ADDENDUM #1 – MARCH 19, 2024

RE: NORTH BEND SCHOOL DISTRICT
North Bay School Kitchen Remodel
Project #23.87

FROM: HGE ARCHITECTS, Inc.
333 South 4th Street
Coos Bay, Oregon 97420
541-269-1166

1 DEMOLITION PLAN
A2.2 SCALE: 1/8" = 1'-0"

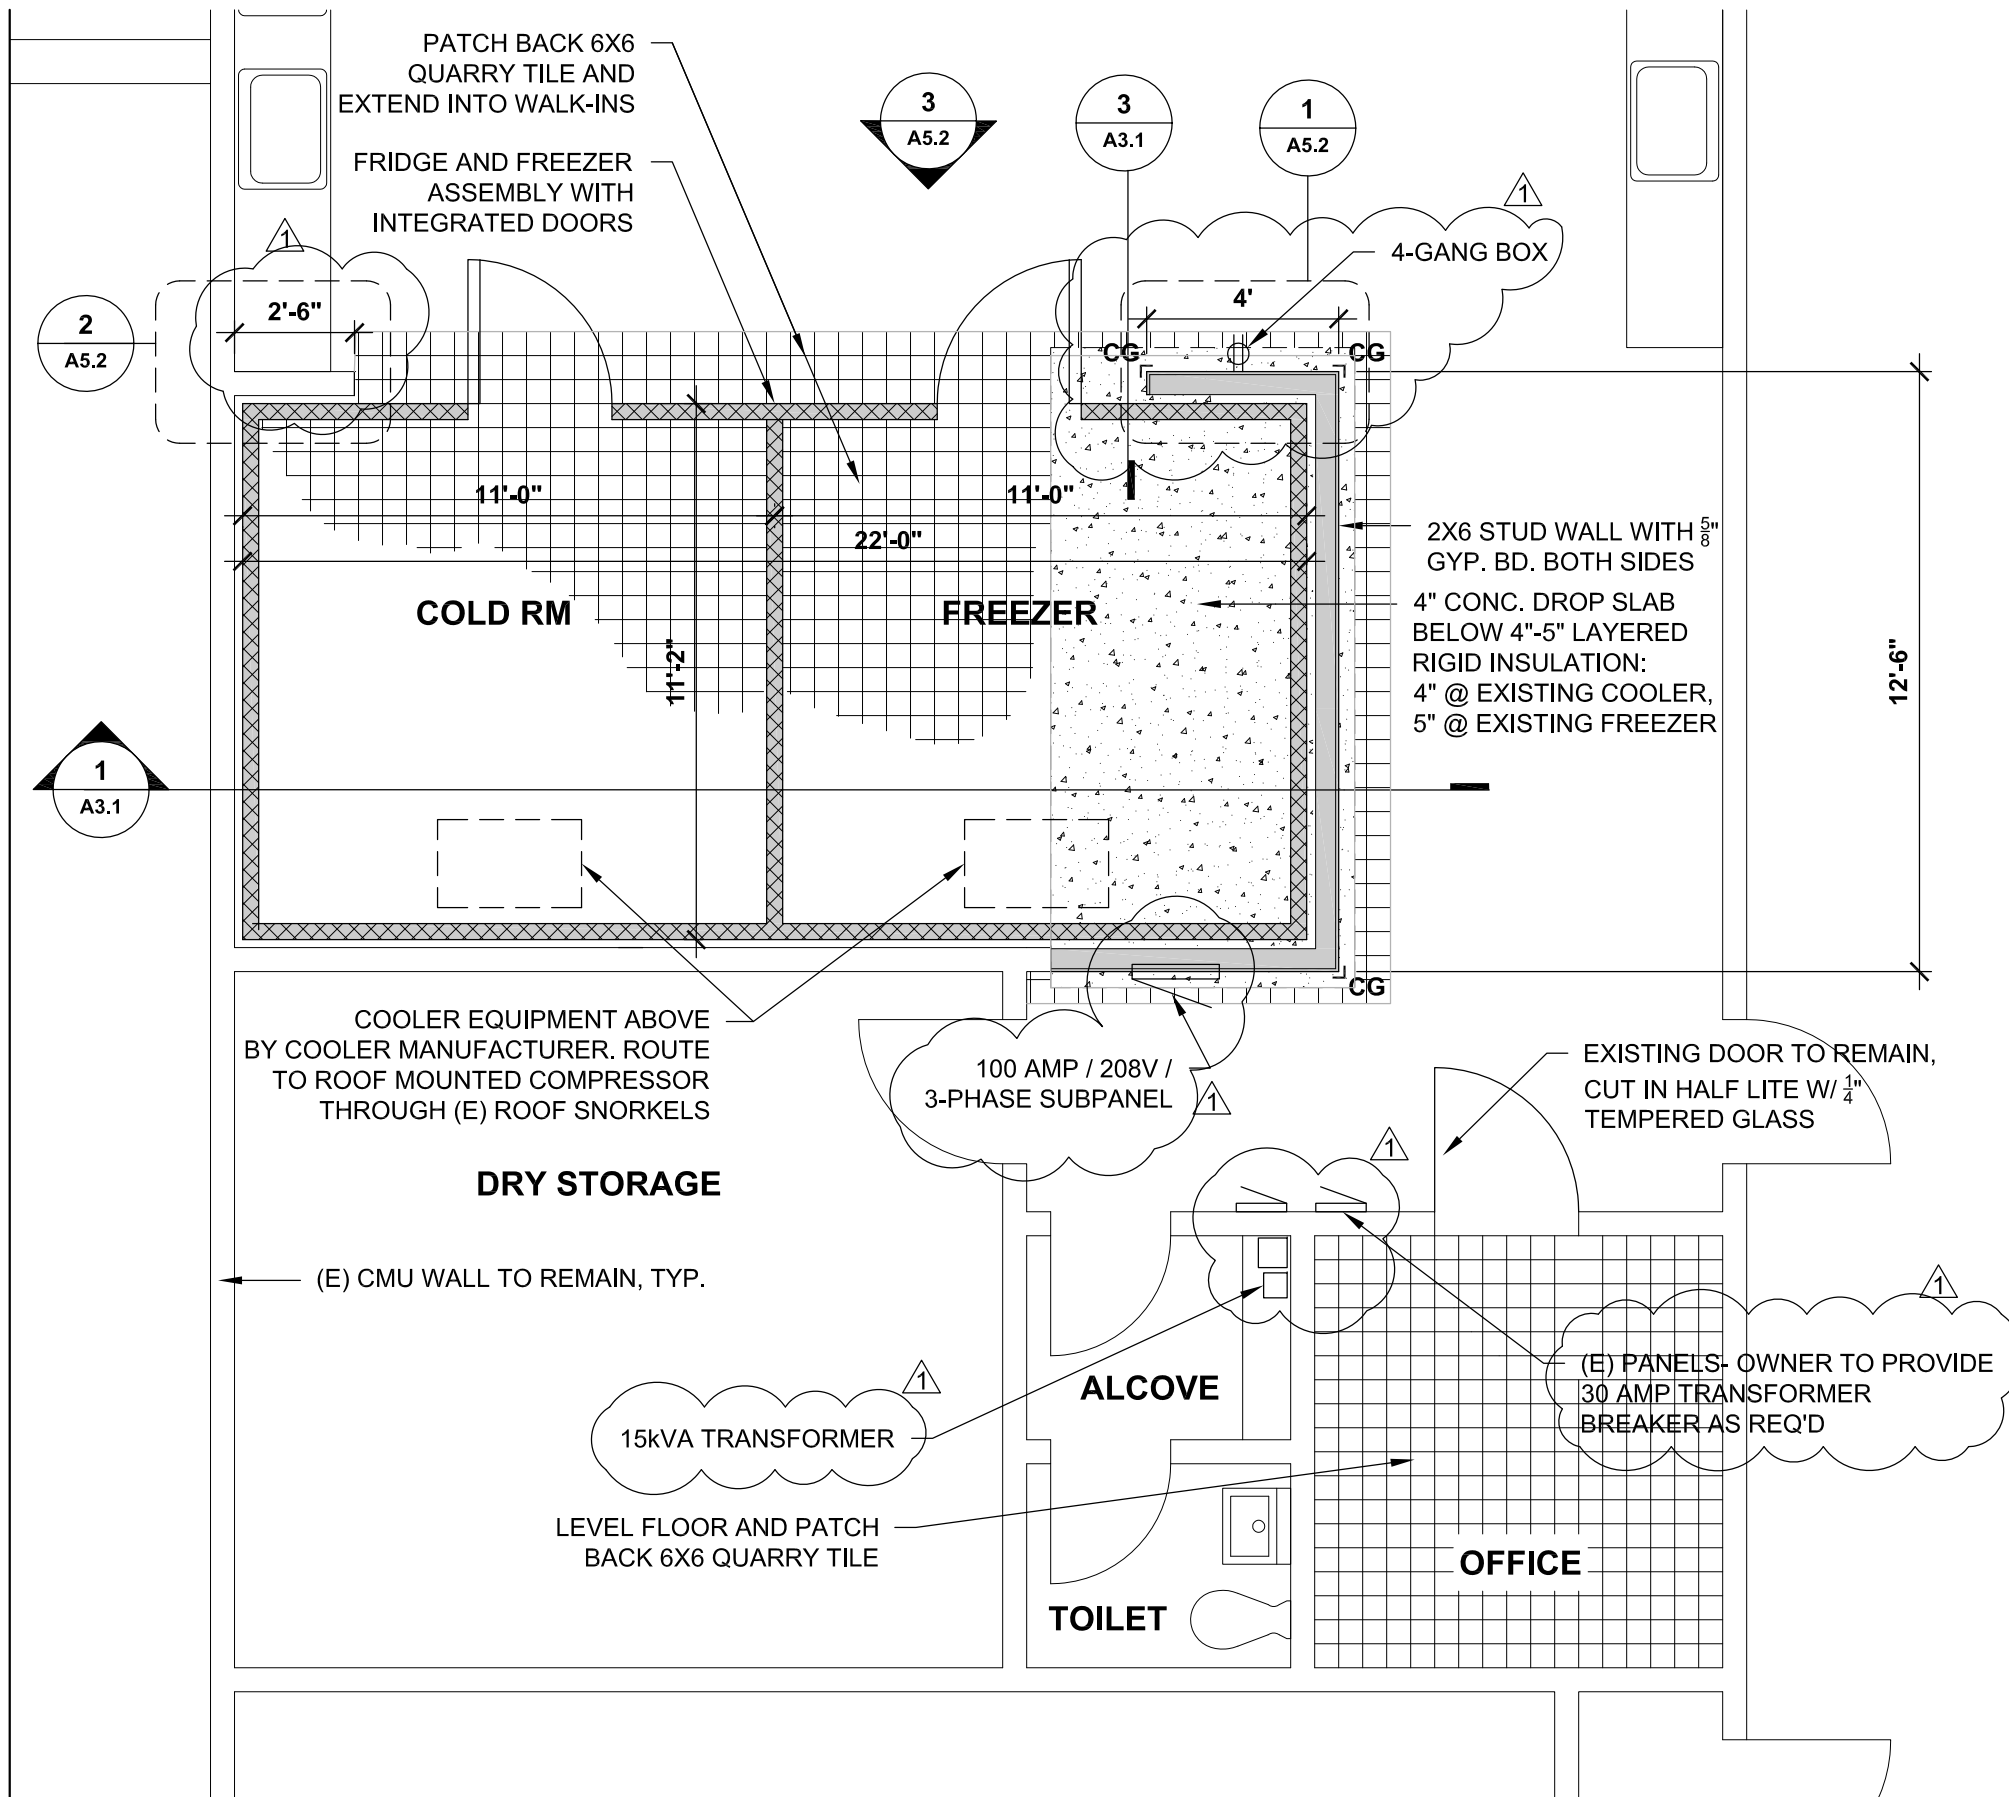
1. **Sheet A2.2 Enlarged Demo Plan:** REPLACE Sheet A2.2 with REVISED Sheet A2.2 attached.
 - a. Revision Summary:
 - i. Changes to electrical equipment in the Alcove / Hallway:
 1. Note regarding relocation of existing electrical equipment: REPLACE with the following note: "(E) TRANSFORMER REMOVED BY OTHERS".
 2. ADD dashed line from Cart Storage to north end of Kitchen & Note: "INGROUND ELECTRICAL, RELOCATE BELOW INSULATION AT FREEZER".
 3. DELETE note: "(E) ELECTRICAL EQUIPMENT & PANELS TO BE RELOCATED TO OTHER SIDE OF ALCOVE WALL".
 - ii. ADD Note: "REMOVE COOLER FLOOR ASSEMBLY: QUARRY TILE & BASE, 2" MORTAR BED, 3" CONCRETE SLAB, 4" & 5" RIGID INSULATION".

- iii. Note regarding removal of ceiling tiles: REVISE as follows: "REMOVE ALL SUSPENDED CEILING TILES AT CEILING & BULKHEAD".
- iv. DELETE Note "REMOVE & BRACE LOW CEILING FRAMING ABOVE AS NEEDED".
- v. DELETE Note "REMOVE & RETAIN CEILING FIXTURES FOR REUSE ABOVE".

1 FLOOR PLAN
A2.3 SCALE: 1/4" = 1'-0"

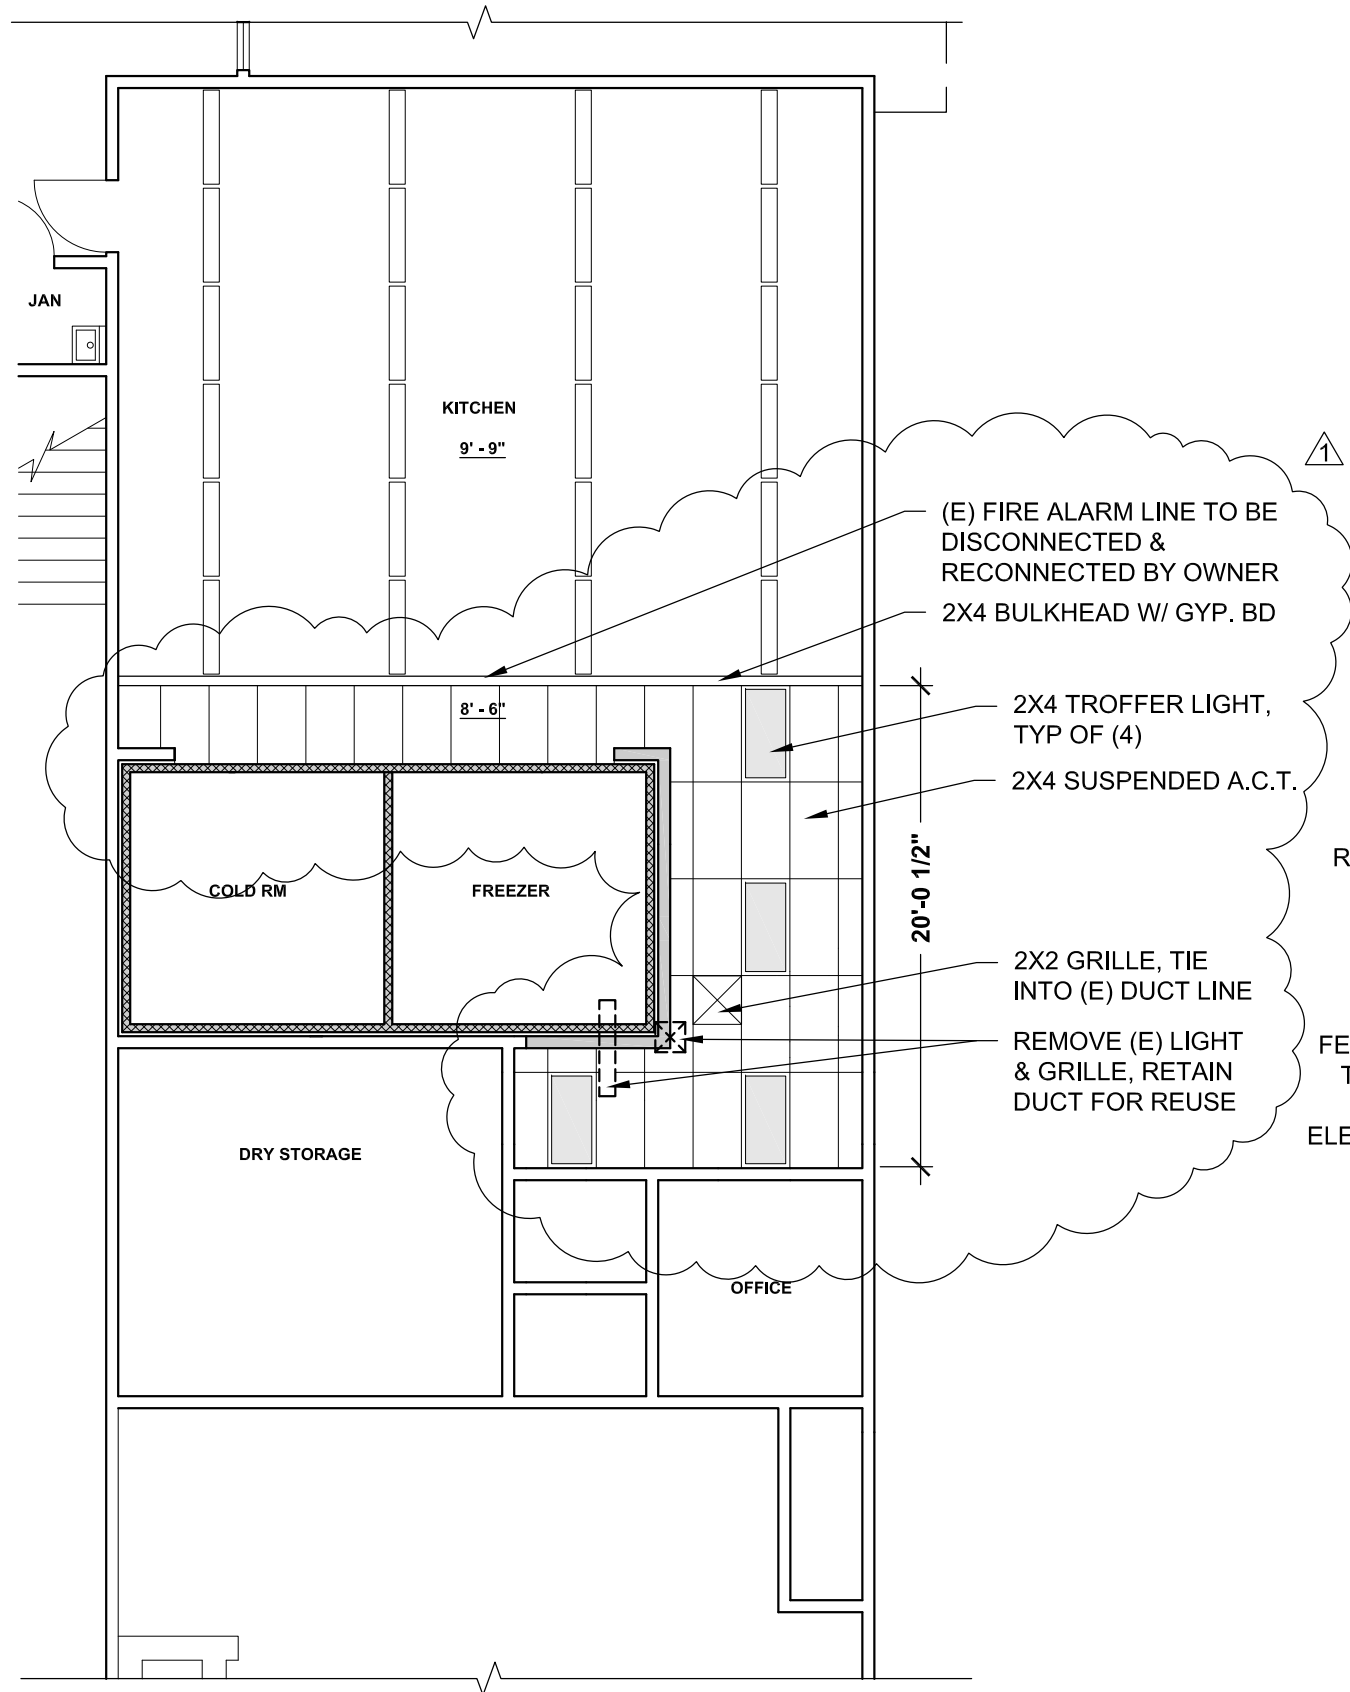
2. Sheet A2.3 Enlarged Floor Plan: REPLACE Sheet A2.3 with REVISED Sheet A2.3 attached.

- i. Changes to electrical equipment in the Alcove / Hallway:
 - 1. Note regarding relocation of electrical equipment into Alcove: REPLACE with note: "15kVA TRANSFORMER".
 - 2. ADD Note: "(E) PANELS- OWNER TO PROVIDE 30 AMP TRANSFORMER BREAKER AS REQ'D"
 - 3. ADD Note: "100 AMP / 208V / 3-PHASE SUBPANEL"
- ii. Changes to the walls enclosing the freezer assembly:
 - 1. ADD dimension string clarifying length of (E) CMU wall to remain at Cold Room door.
 - 2. Lengthen the stud wall adjacent to the freezer door to 48", add electrical outlet.
 - 3. ADD Note: "4-GANG BOX".

2 REFLECTED CEILING PLAN
SCALE: 1/8" = 1'-0"

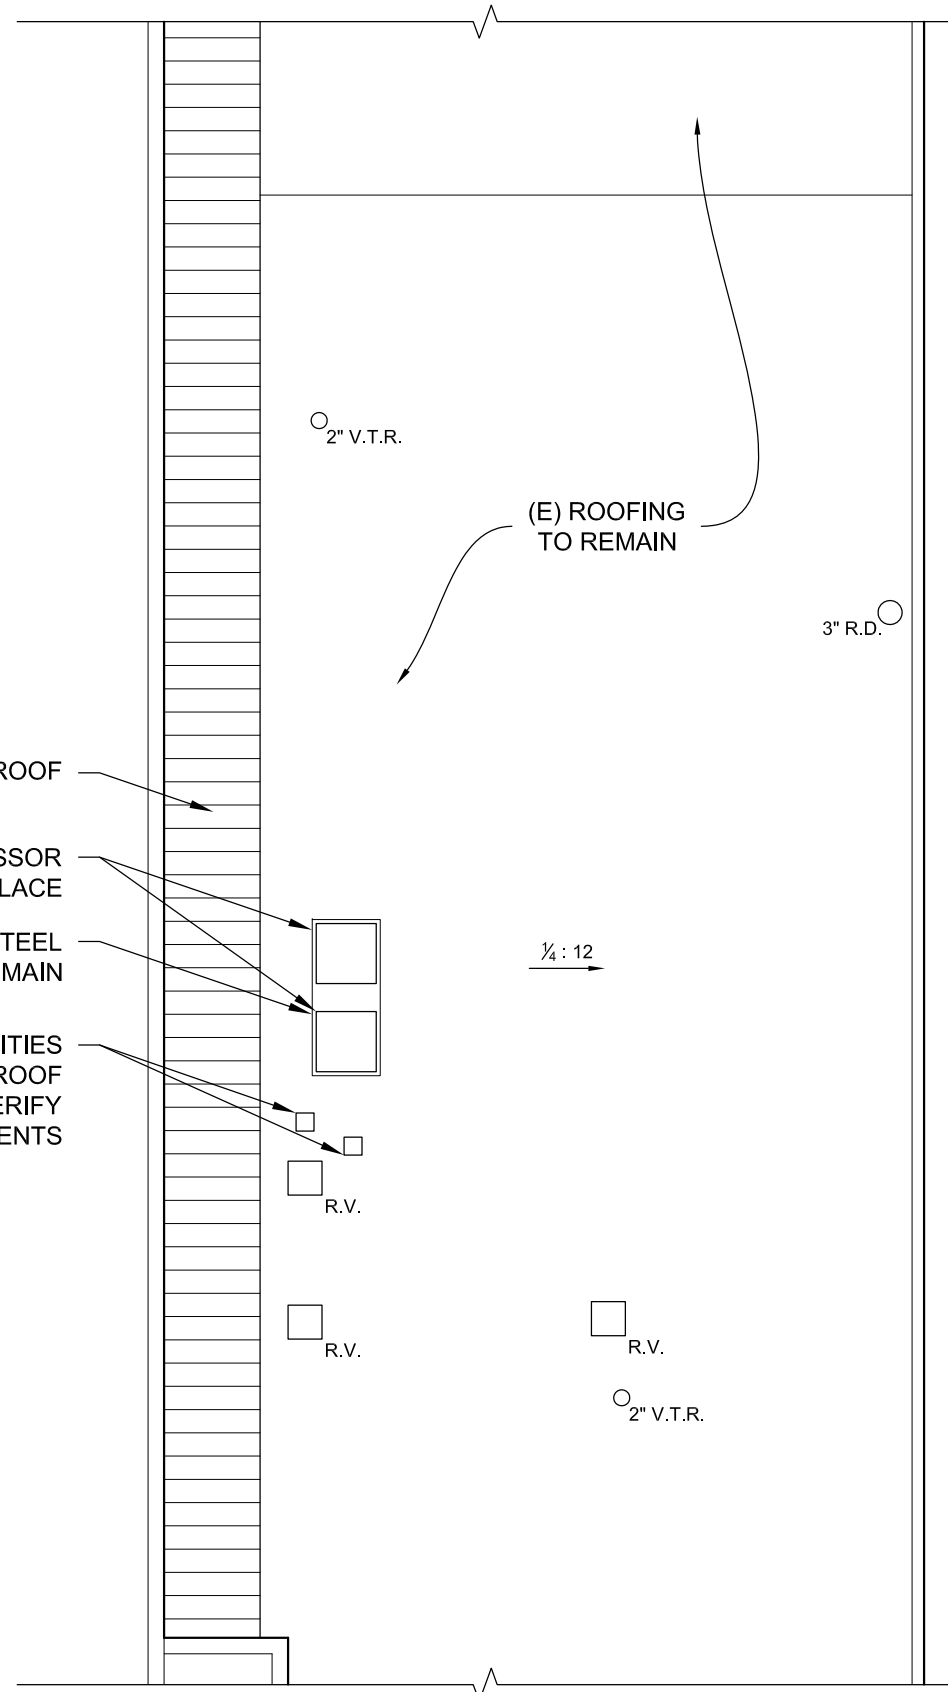
3. Sheet A2.4 RCP and Roof Plan: REPLACE Sheet A2.4 with REVISED Sheet A2.4 attached.

- i. Drawing 2, Reflected Ceiling Plan:
 - 1. Change the soffit ceiling from a glue-on A.C.T. assembly to a suspended A.C.T. assembly. Lighting & mechanical to be integrated into suspended ceiling grid per notes.
 - 2. ADD Note: "(E) FIRE ALARM LINE TO BE DISCONNECTED & RECONNECTED BY OWNER".
